General Response:

Anonymous Referee #1

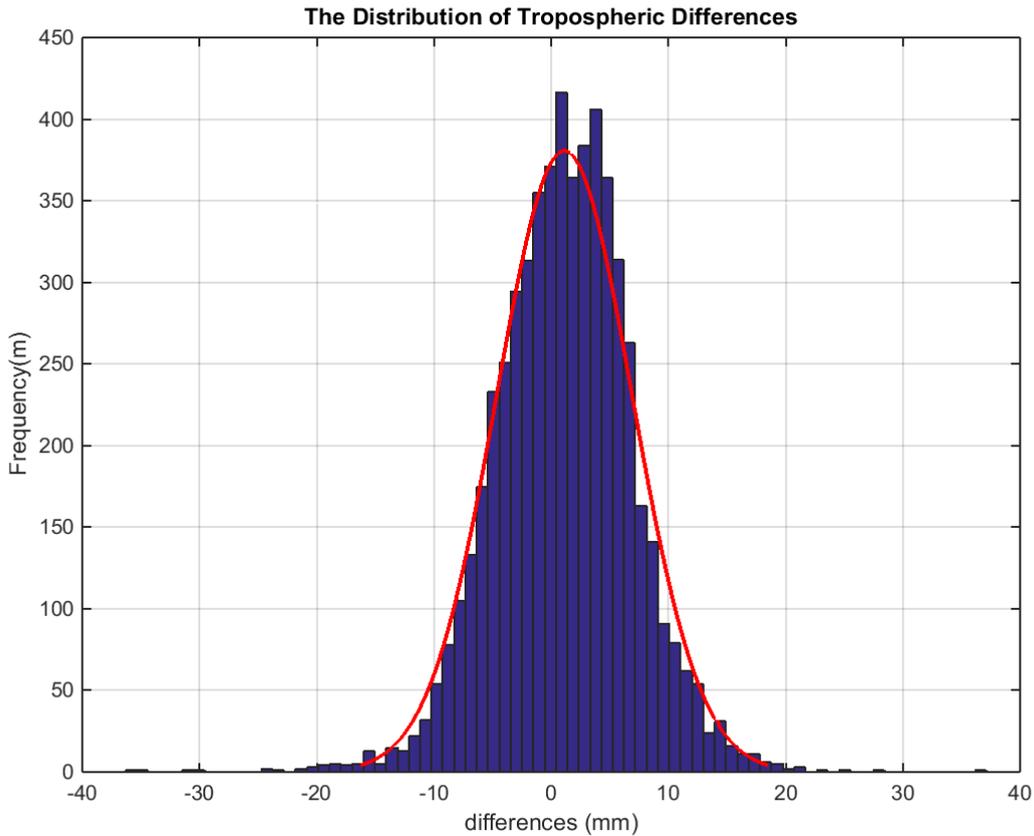
7. I have also general comment to the all results presented in tables: 5, 6, 7, 9, and 10. I think that in case of ZTD differences it will be nice to see also maximum and minimum values. I also advise Authors to think about replacing mean values into a median.

We could use the median in case of our solutions have a non-normal distributed value as provided in the figure below.
